Moss Vale Station and Stabling Yard Upgrade

Determination Report

Status:	Final
Date of issue:	24 April 2024
Revision:	4
Document author:	AECOM Australia, Transport for NSW
Document reviewers:	Transport for NSW

Figure 3 Changes to the proposal

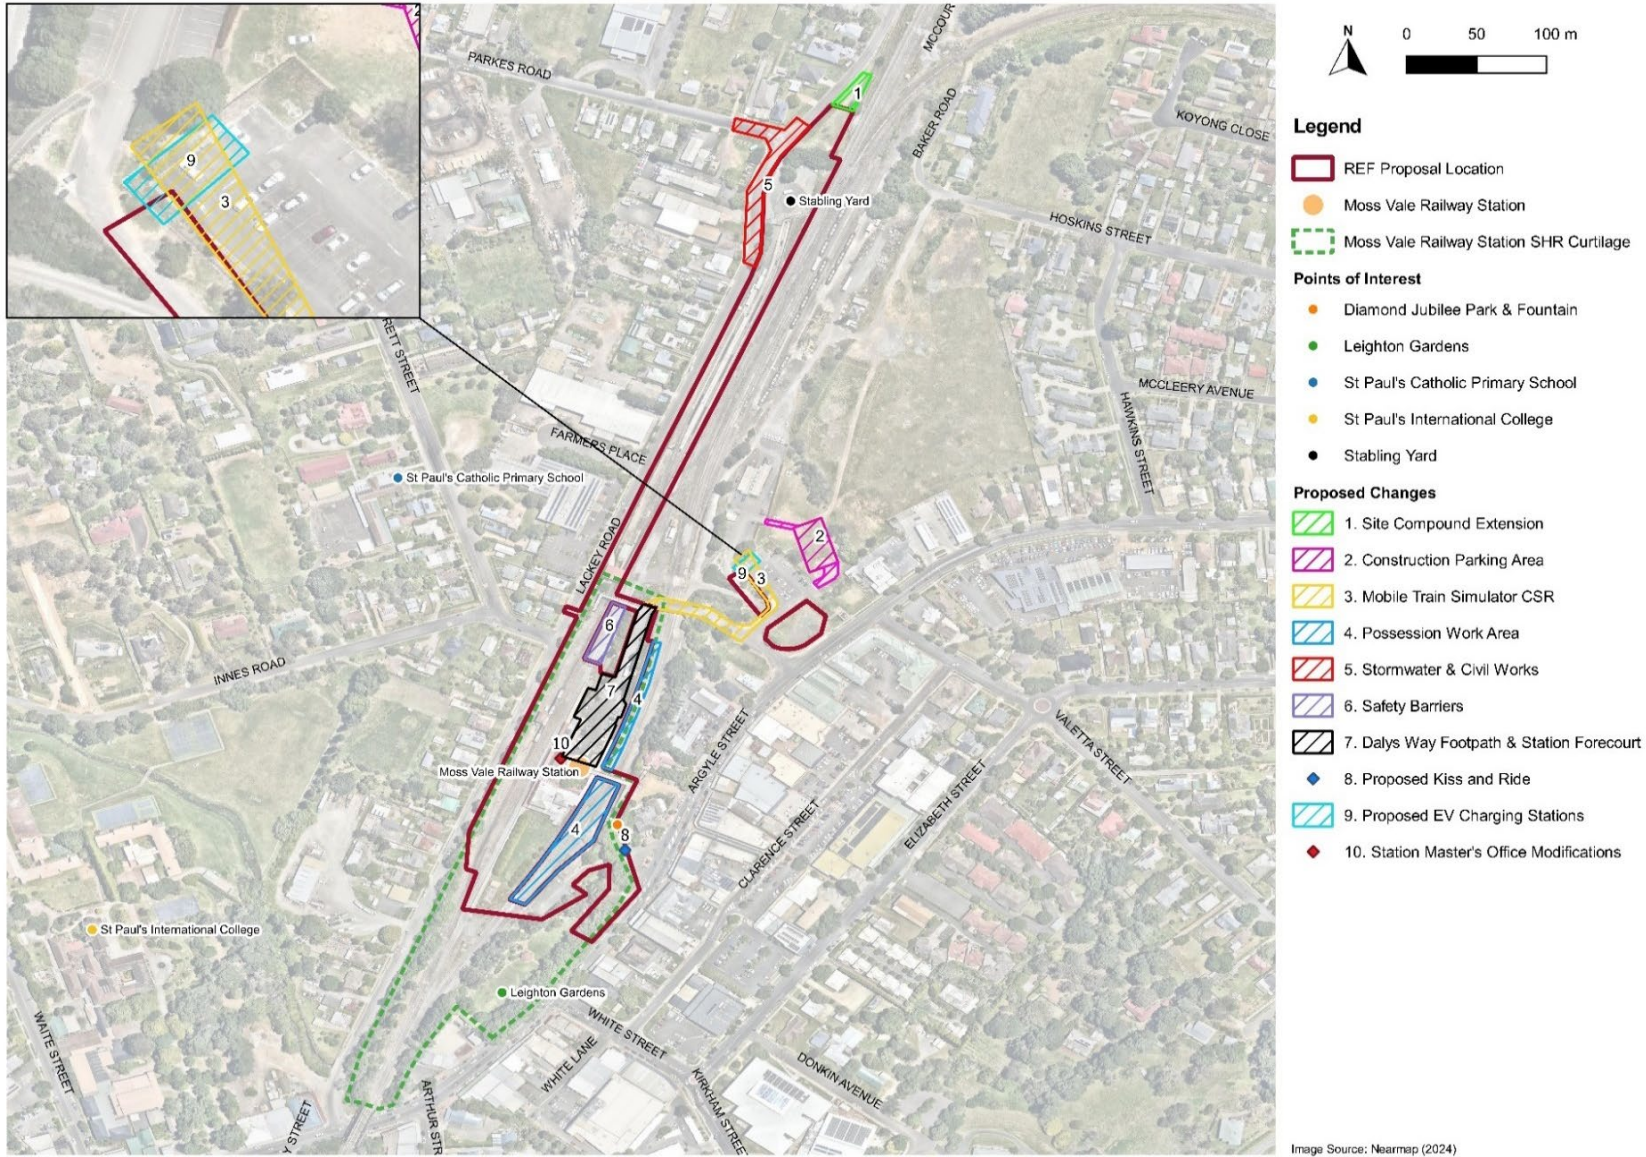
Proposed Activity	Overview of proposed change	Details of proposed change
1. Extension to the site compound area	A minor extension to the site compound area is proposed to allow additional space for adequate driveway access during construction. The extension is approximately 30 metres north of the extent of the existing proposal area, and within Council land, as shown in Figure 3.	<p>The extension occurs on primarily vacant, grassed land. Vegetation within the proposed extension area is limited to two exotic trees. The trees would not be impacted and would be managed with Tree Protection Zones (TPZs) and in accordance with relevant Transport guidelines.</p> <p>The land utilised for the site compound would be reinstated once construction is complete.</p> <p>As per Condition of Approval 2, licences, and approvals would be sought from relevant authorities where required.</p>

Proposed Activity	Overview of proposed change	Details of proposed change
	<p>access/egress points, the main access through the existing commuter car park and a secondary access to the west through land owned by Pacific National.</p> <p>The proposed construction vehicle parking area is shown in Figure 3.</p>	<p>To establish the parking area, the area would be regraded and road base or similar material applied to make a suitable surface. Erosion and sediment controls would be installed as required. Access would be managed with lockable gates and appropriate signage.</p> <p>Utilising this site would reduce reliance on street parking for construction workers.</p> <p>The proposed parking area would be made good upon construction completion, with road base removed and grass reinstated.</p>
<p>3. Combined services route (CSR) for the mobile train simulator</p>	<p>Trenching is required from the mobile train simulator compound to the station forecourt to install a CSR. The location of the CSR works is shown in Figure 3. This is in addition to the CSR works previously described as part of the proposal in the REF.</p>	<p>The CSR route includes the construction of two service crossings under the rail line and would be trenched to a depth of up to 600 millimetres, from the mobile train simulator compound to an existing pit on Dalys Way. The area would be reinstated following completion.</p> <p>Works would be carried out over a one week period including night time hours to minimise disruption to commuters. Traffic control would be in place to manage a contraflow arrangement, i.e. one lane would be open at all times to maintain access to the station.</p> <p>While the works would likely be staged during other mobile train simulator activities, currently no other night works associated with the proposal are planned at the same time. A noise assessment has been undertaken for this change and is discussed in Table 3.</p>

<p>4. Occupation of rail corridor for construction during rail possession periods</p>	<p>Rail possession activities, including platform resurfacing and crane use, would require the contractor to occupy the rail corridor to access the platforms. The location is shown in Figure 3.</p>	<p>Although not technically a change in the construction methodology previously proposed, it is noted the area was not shown in the proposal boundary of the REF. This activity would be limited to possession periods.</p>
<p>5. Stormwater drainage, water supply, civil and landscaping works</p>	<p>Stormwater drainage and water supply upgrades are required to meet increased drainage and supply requirements of the stabling yard upgrade.</p> <p>This would include installation of an onsite stormwater detention (OSD) tank, decommissioning and removal of existing</p>	<p>Design development since the REF has identified the need to meet increased drainage and water supply requirements of the stabling yard upgrade.</p> <p>Trenching would be required on Lackey Road and Parkes Road to a depth and width of up to one metre. This activity would occur on Council land only. Private property would not be directly impacted.</p>

Proposed Activity	Overview of proposed change	Details of proposed change
	<p>stormwater infrastructure, connection to Council drainage, and construction of a new pit.</p> <p>Minor civil, and landscaping (turfing) works would be required to support the services upgrade. This would include road, kerb and gutter and signposting works. The location of these works is shown in Figure 3.</p>	<p>Works are expected to be undertaken over a four-night period to minimise traffic impacts. While the works would likely be staged during the stabling yard activities, currently no other night works associated with the proposal are planned at the same time.</p> <p>As per Condition of Approval 2, consultation, licences, and approvals would be sought from relevant authorities where required (refer Appendix B).</p>

6. Installation of temporary safety barriers	<p>The installation of temporary safety barriers would be required within the track area south of the Lackey Road / Dalys Way pedestrian overpass to delineate the construction area and live track. The location is shown in Figure 3.</p>	<p>The installation of safety barriers would be limited to the rail corridor on TAHE land and would be removed upon construction completion</p>

7. Change to station forecourt car park layout and Dalys Way footpath	<p>Design development of the station forecourt car park and the Dalys Way footpath has resulted in modifications to improve pedestrian and vehicle circulation and meet DSAPT compliance. The location of this scope is shown in Figure 3.</p>	<p>Design development since the REF has refined the proposed parking layout to improve the safe circulation of pedestrians from car parking and bicycle racks, while maintaining adequate space for bus movements.</p> <p>The design modification would result in the permanent removal of an additional parking space to what was described in the REF. The net permanent parking spaces in the station forecourt area would be 21, consisting of 17 standard and three accessible parking spaces and one loading space.</p> <p>The design development provides DSAPT compliant accessible footpaths and rest bays along Dalys Way, allowing improved access to the station for those with a disability, limited mobility, parents/carers with prams and passengers with luggage. Civil works relating to the footpath widening would result in an encroachment to vegetation, which was previously designated for retention in the REF. Discussion of biodiversity impacts and mitigation measures are provided in Table 3.</p>

8. New kiss and ride zone on Argyle Street	<p>Two existing 1P street parking spaces would be converted to provide an accessible kiss and ride zone for commuters. The proposed kiss and ride zone would be located on Argyle Street,</p>	<p>There are currently five 1P parking spaces at the eastern station entrance on Argyle Street. This modification proposes to convert two 1P parking spaces into an accessible kiss and ride zone. No changes are proposed to the remaining three 1P parking spaces at this location.</p>

Proposed Activity	Overview of proposed change	Details of proposed change
	adjacent to the Diamond Jubilee Park as shown in Figure 3.	Design development since the REF has refined accessibility from Argyle Street. The reconfiguration would improve access to the station for those with a disability, limited mobility, parents/carers with prams and passengers with luggage, and has also been designed to improve safety of vehicles, pedestrians and cyclists accessing the station via Argyle Street.

9. New Electric Vehicle (EV) charging stations	Six existing commuter parking spaces would be converted to EV charging stations at the northern commuter car park, as shown in Figure 3.	<p>The NSW Government has committed to achieving net zero by 2050 and the NSW <i>Electric Vehicle Strategy</i> (NSW Government, 2021) is one part of meeting this goal.</p> <p>The investment of installing six electric vehicle stations at Moss Vale Station commuter car park increases charging accessibility for commuters and supports the transition in NSW to a low-emissions future.</p> <p>The upgrading of existing unpowered spaces will help close barriers to EV adoption and aids the movement towards sustainable transport.</p> <p>The EV charging stations would be converted from existing commuter spaces. It is expected that the EV charging facilities would be for use by EVs only.</p> <p>Installation of EV charging stations would include a CSR continued from the mobile train simulator CSR, which would involve trenching to a depth of 600 millimetres. Safety bollards would also be installed to prevent damage to the EV charging stations.</p> <p>Construction is expected to be undertaken over a one week period. During this time six commuter spaces would be temporarily unavailable.</p>

10. Modifications to the Station Master's Office	Modifications to the Station Master's Office would be required for DSAPT compliance. Works include flooring upgrade, installation of new joinery (colour/texture to match existing), door, counter and ramp adjustments.	<p>The modifications would improve safe access to station services for those with a disability, limited mobility and parents/carers with prams.</p> <p>The modifications would include a condition assessment of existing heritage floor subframe, installation of new independent post supports, bearers and subframe and reinstatement of existing floorboards. Associated joinery, door, ramp adjustments, cabinetry and partitioning works would be sympathetic to the existing heritage characteristics and match the existing fabric. Heritage is further discussed in Table 3.</p>
